A D D E N D U M

Project No.: 2501101
Project: EACS Restroom Renovations

Addendum No: 02
Date: 04/02/2025

ADDENDUM NO. 02, to Drawings and Specifications dated 03/12/2025, for the EACS Restroom Renovations for the East Allen County Schools; as prepared by ELEVATUS Architecture, 111 E. Wayne Street, Suite 555, Fort Wayne, IN 46802

Accessibility Diagrams
1/4" = 1'-0"

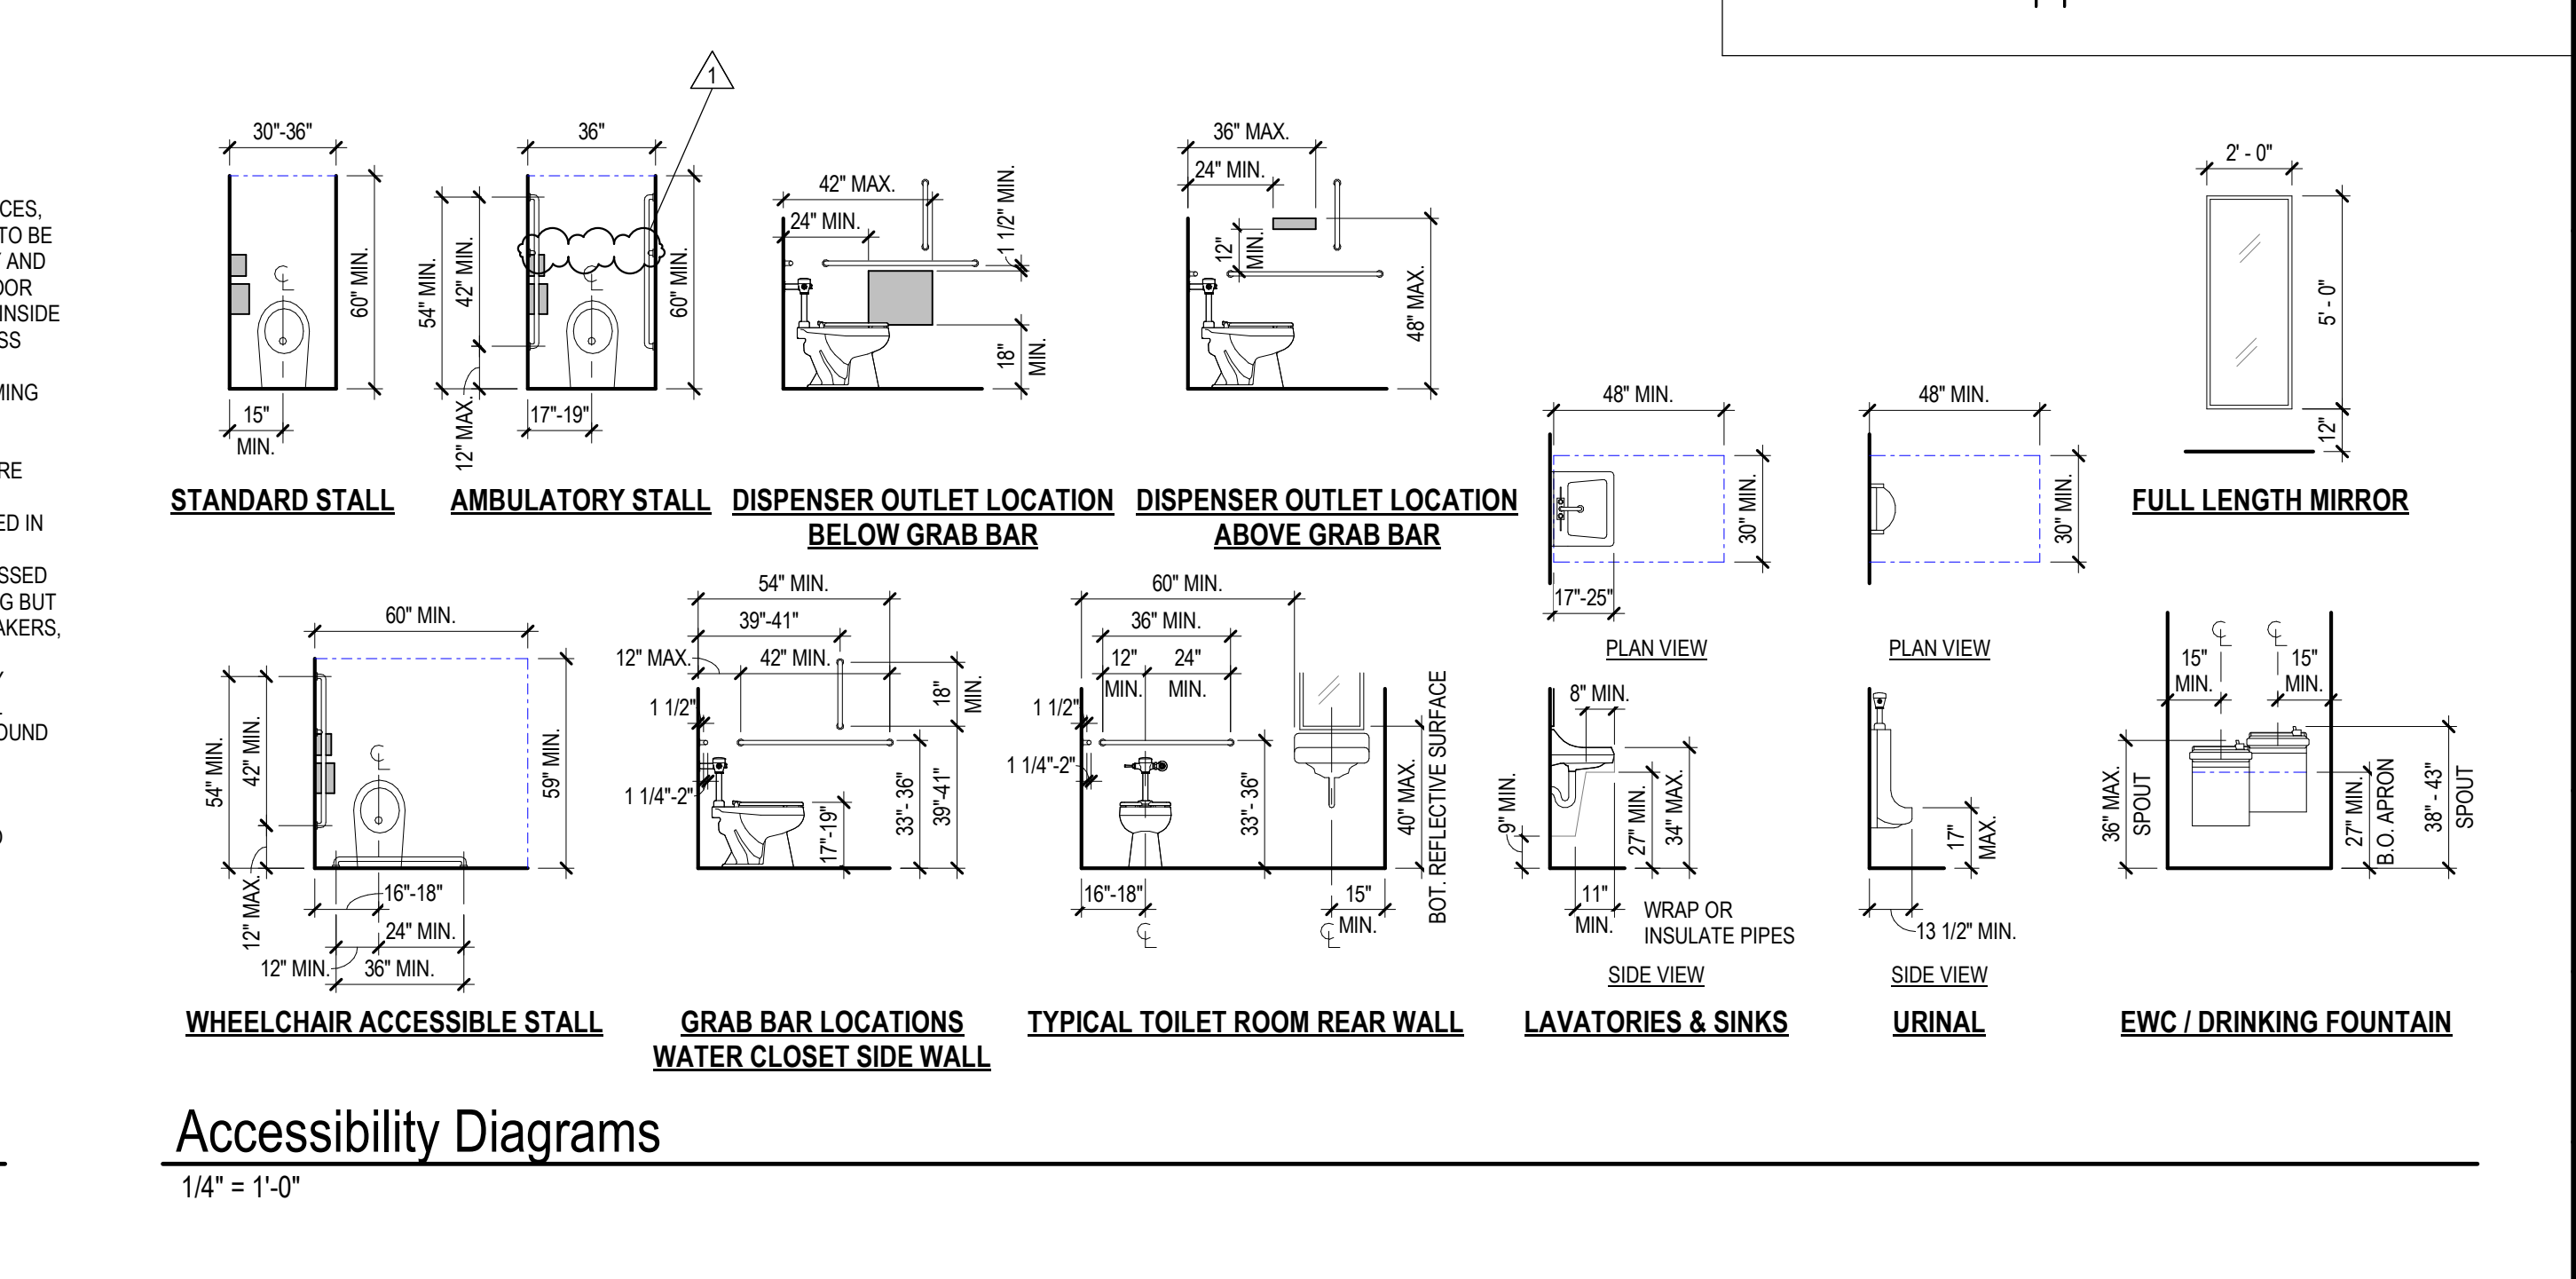
ITEM NO. 1.01 - DRAWING NO. A-001 Architectural Information Sheet

- A. Addition of vertical grab bars to ambulatory stall diagram on the Accessibility Diagrams.

PLAN NORTH
1 First Floor Architectural Demolition Plan - Base Bid
 1/4" = 1'-0"

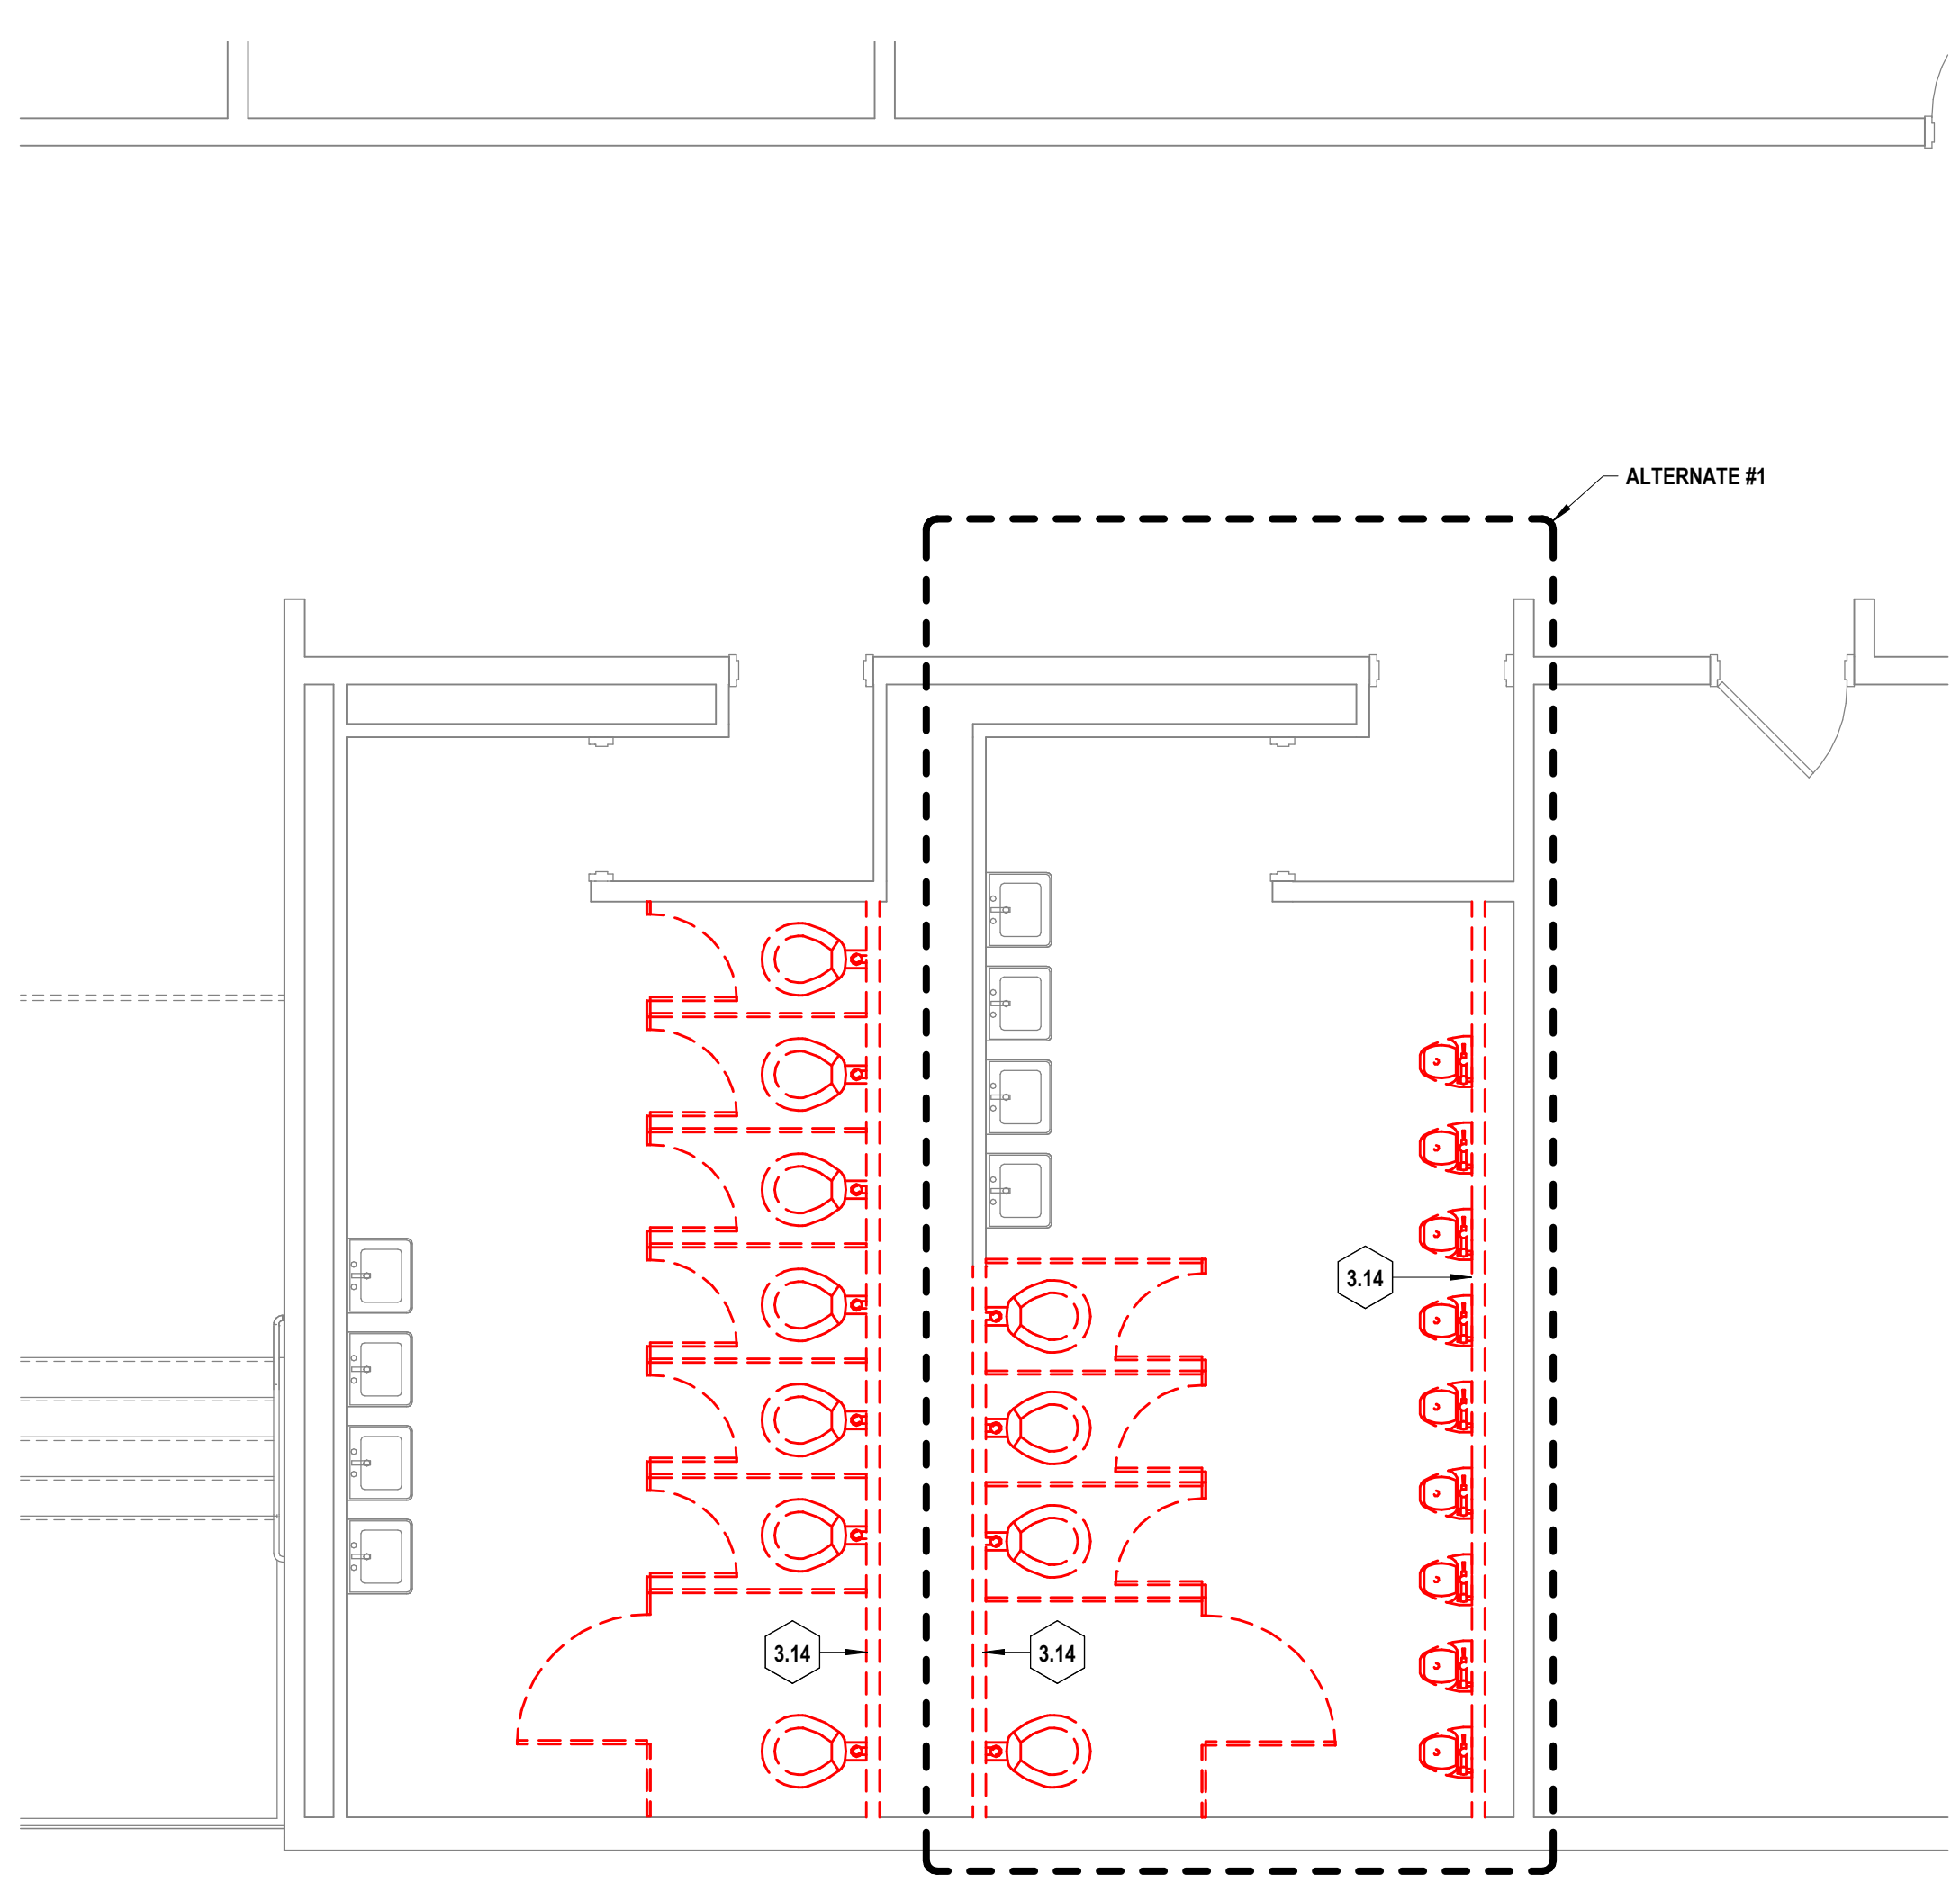
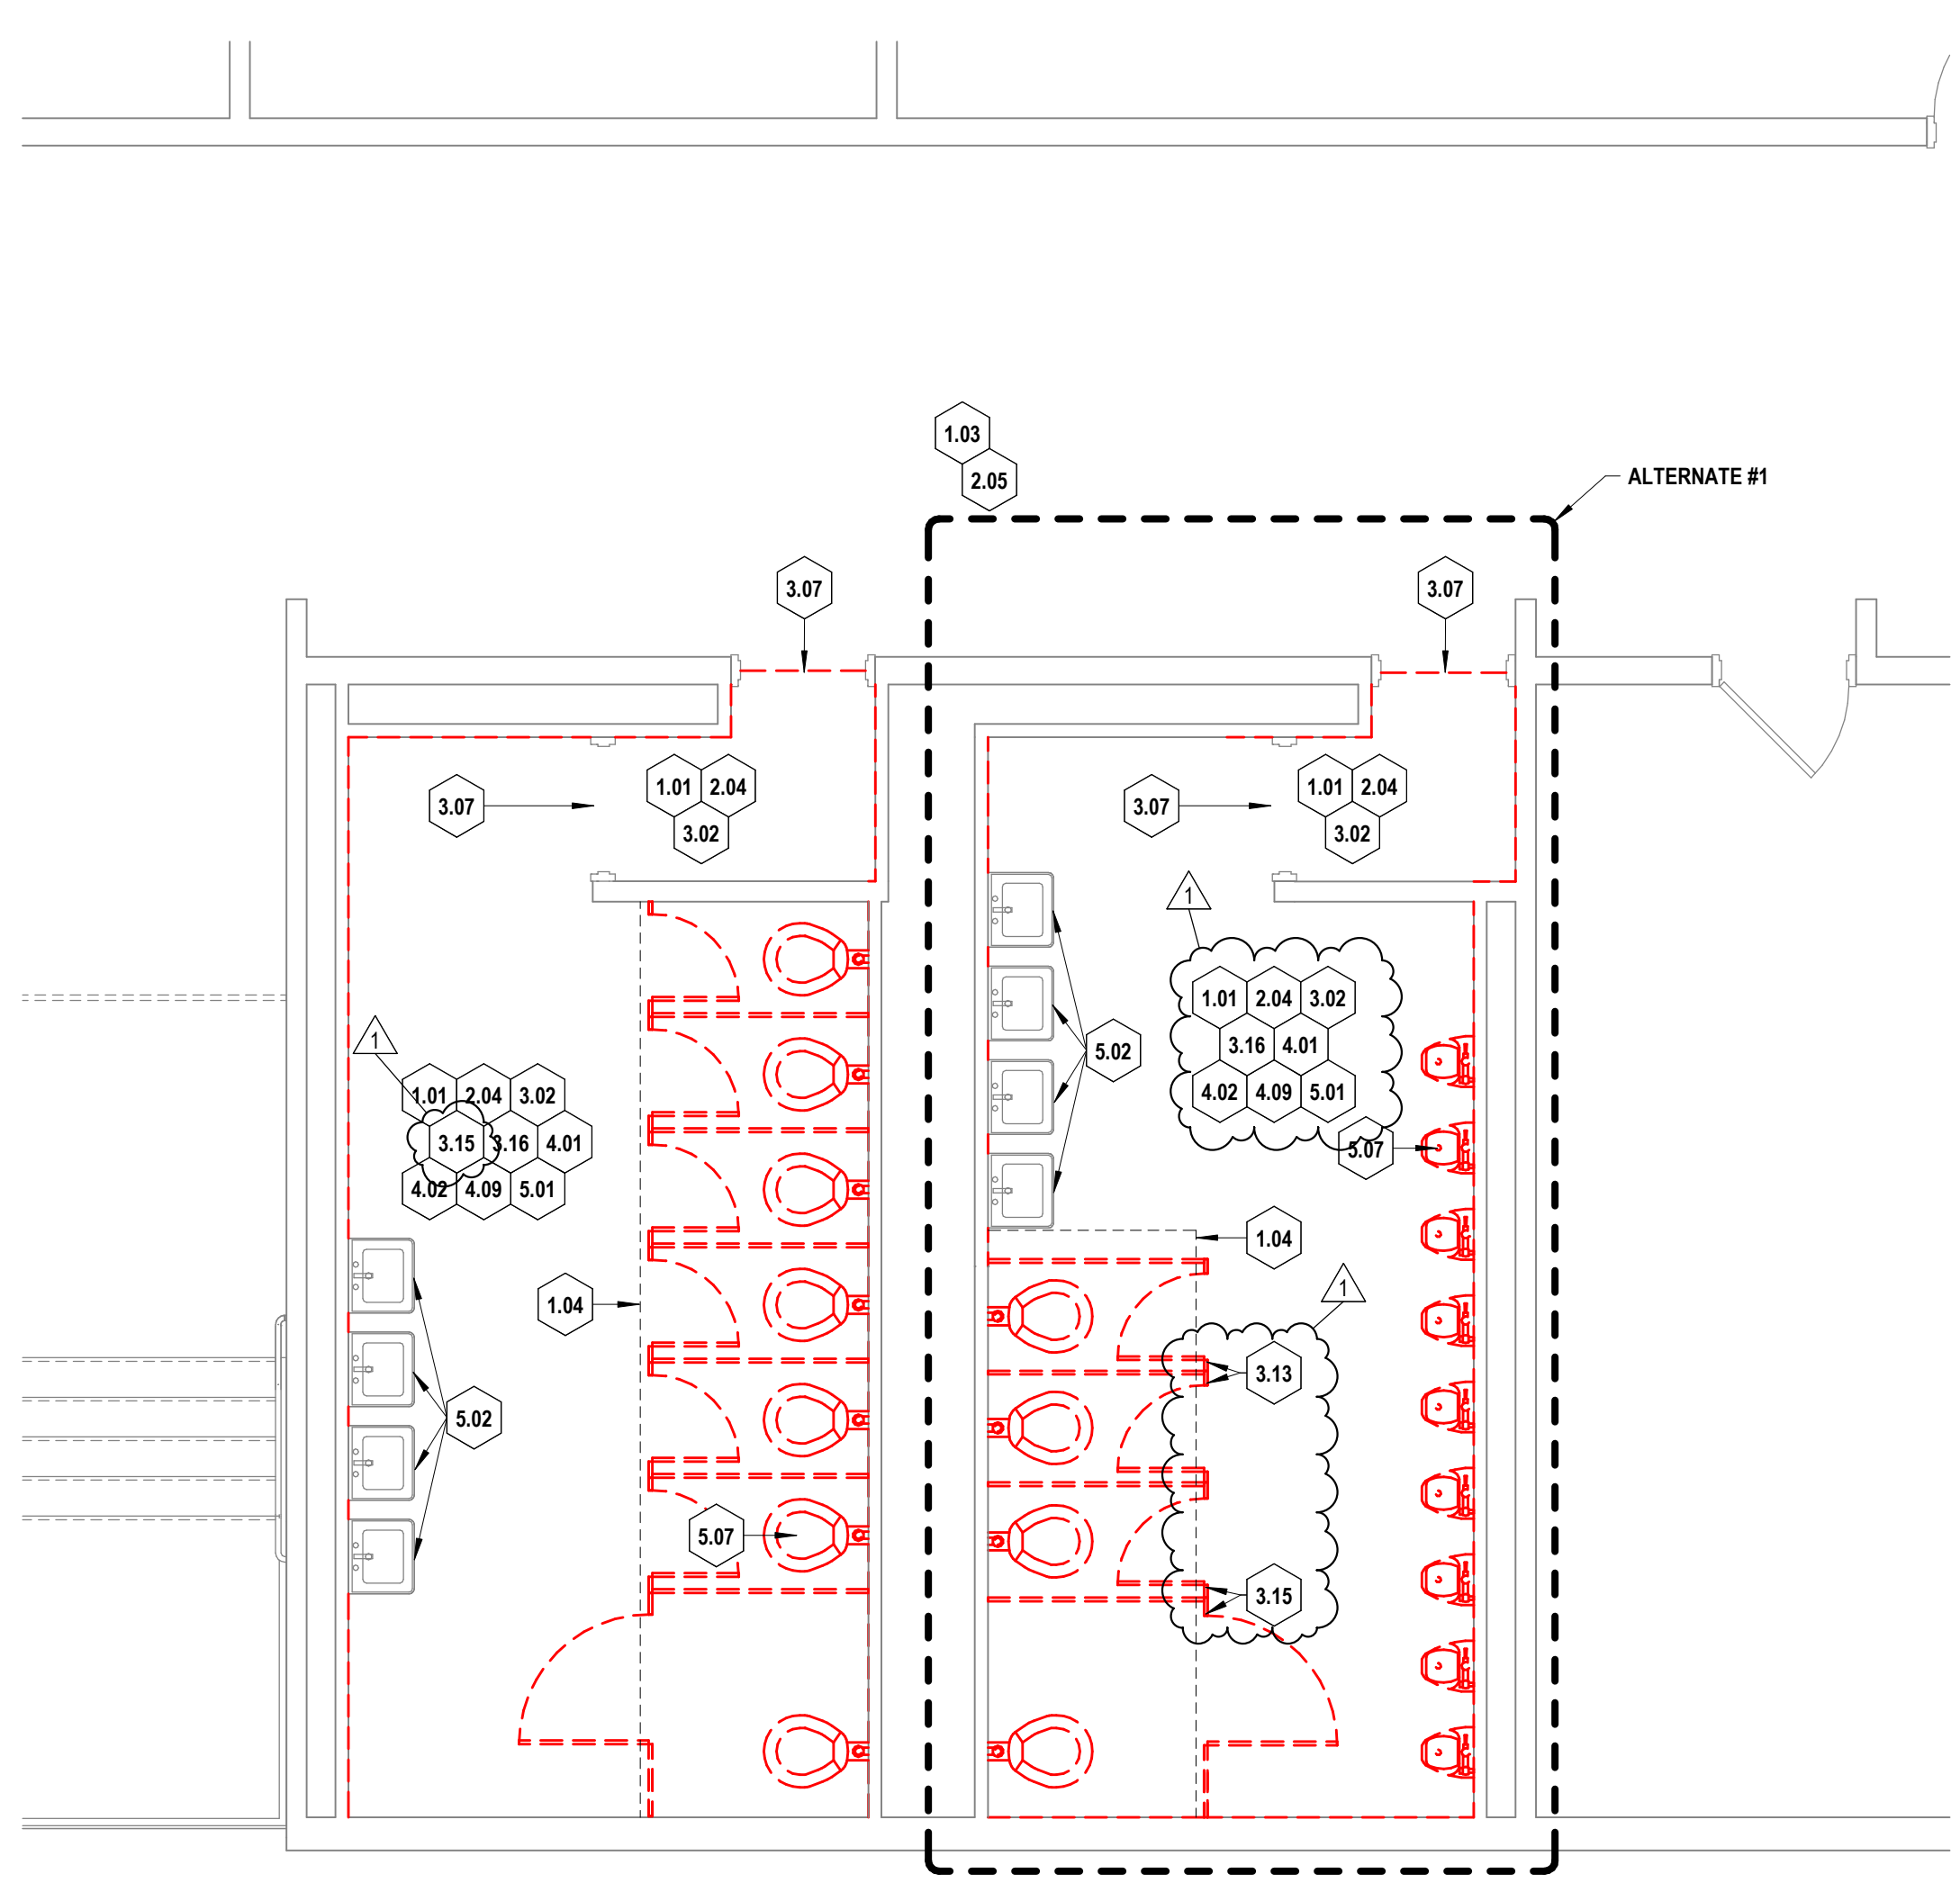
ITEM NO. 1.02 - DRAWING NO. AD101 Architectural Demolition Plan – First Floor

- A. Addition of Demolition Plan Note 3.15 to Demolition Plan Notes Schedule.
- B. Addition of Demolition Plan Note 3.15 to First Floor Architectural Demolition Plan – Base Bid.
- C. Revision to Demolition Plan Note 3.13 on Demolition Plan Notes Schedule.
- D. Revision to the location of Demolition Plan Note 3.13 on First Floor Architectural Demolition Plan – Base Bid.
